SUNDRY NOTICES AND REPORTS ON WELLS

8. Well Name and No. DILLON 31 FED COM/301H

EOG respectfully requests an amendment to our approved APD for this well to reflect the following changes:

Revised Permit Information 07/18/2022:

WELL LOCATION AND ACREAGE DEDICATION PLAT

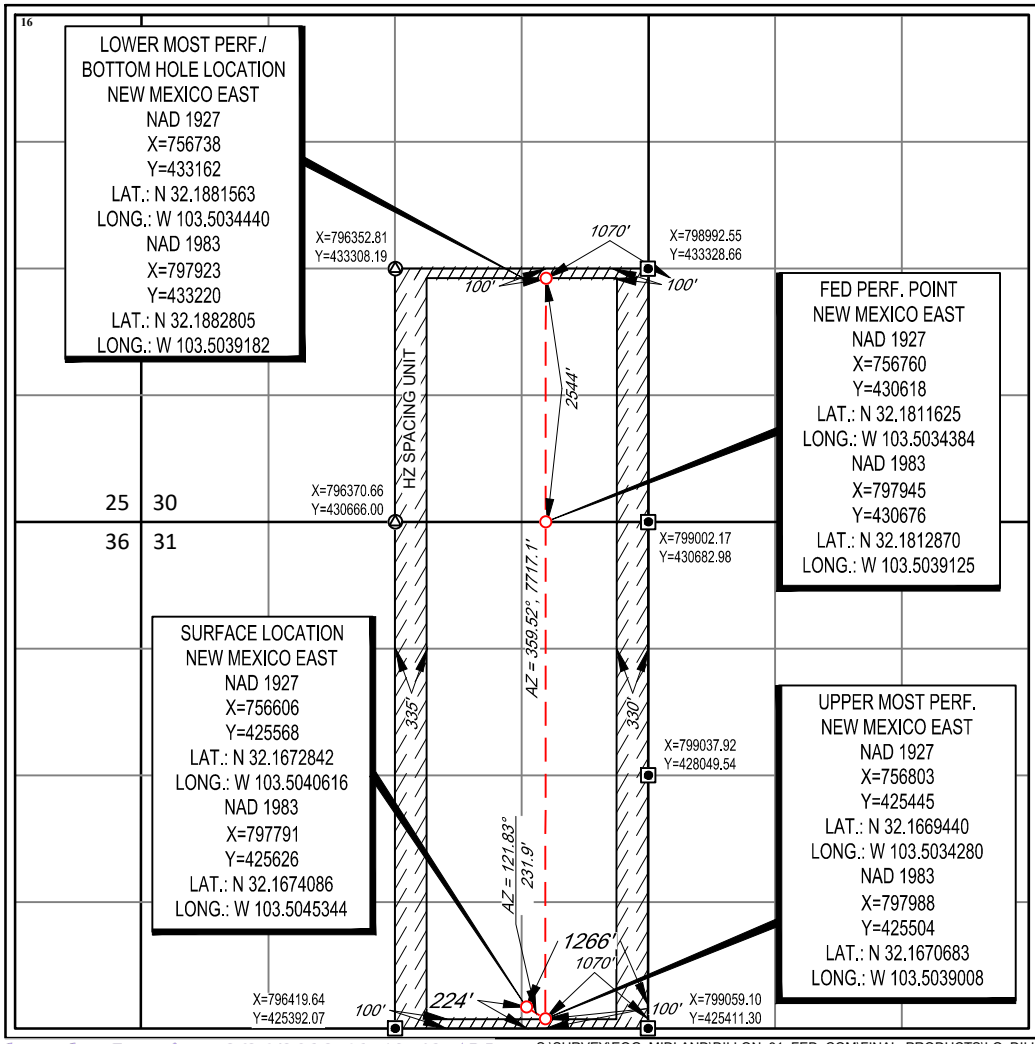
Change BHL from T-24-S, R-34-E, Sec 30, 2545' FSL, 660' FEL, Lea Co., NM, to T-24-S, R-34-E, Sec 30, 2544' FSL, 1070' FEL, Lea Co., N.M.

UL or lot no.	Section	Township	Range	Lot Idn	Feet from the	North/South line	Feet from the	East/West line	County
I	30	24-S	34-E	-	2544'	SOUTH	1070'	EAST	LEA

Revised Wellbore

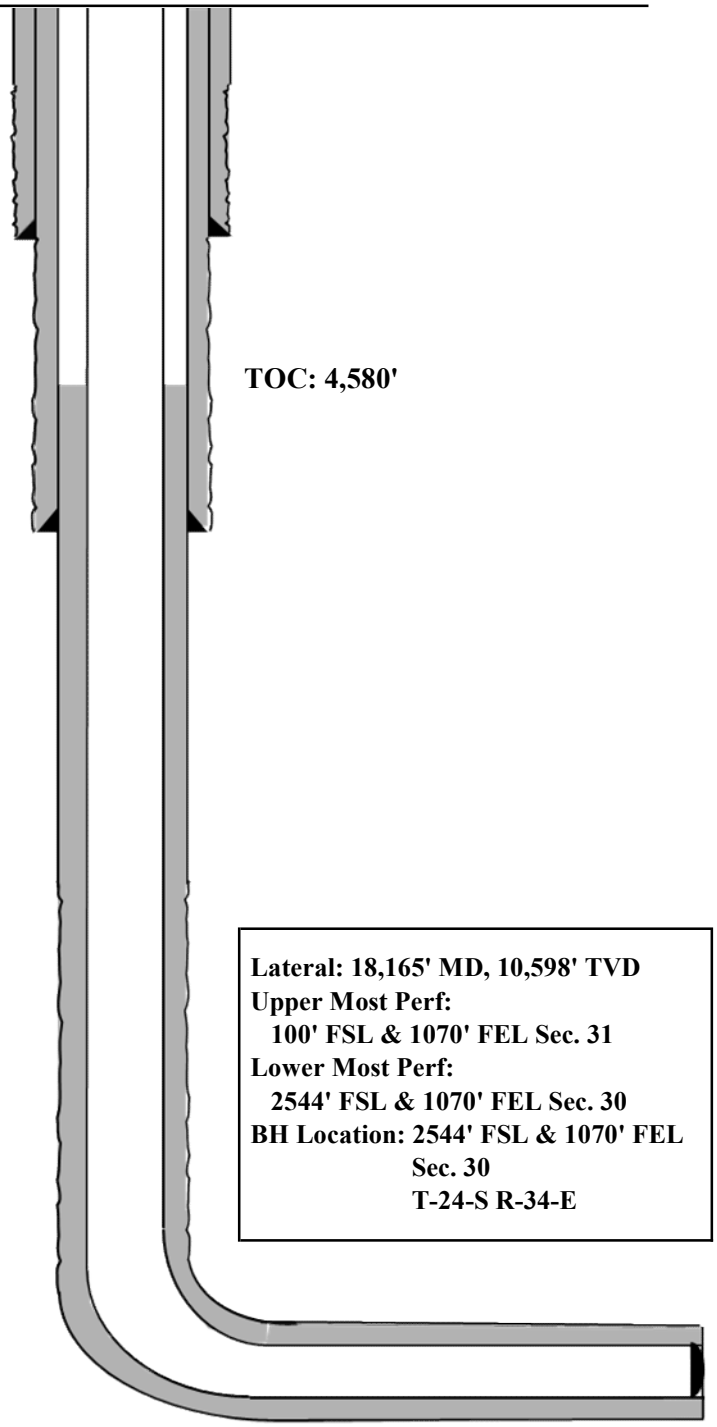
Update casing and cement program to current design.

Bit Size: 16"
13-3/8", 54.5#, J-55, STC
@ 0' - 1,230'

Bit Size: 12-1/4"
9-5/8", 40.#, J-55, LTC
@ 0' - 4,000'
9-5/8", 40.#, HCK-55, LTC
@ 4,000' - 5,080'

Bit Size: 7-7/8"
5-1/2", 17.#, HCP-110, LTC
@ 0' - 18,165'

Lateral: 18,165' MD, 10,598' TVD
Upper Most Perf:
100' FSL & 1070' FEL Sec. 31
Lower Most Perf:
2544' FSL & 1070' FEL Sec. 30
BH Location: 2544' FSL & 1070' FEL
Sec. 30
T-24-S R-34-E
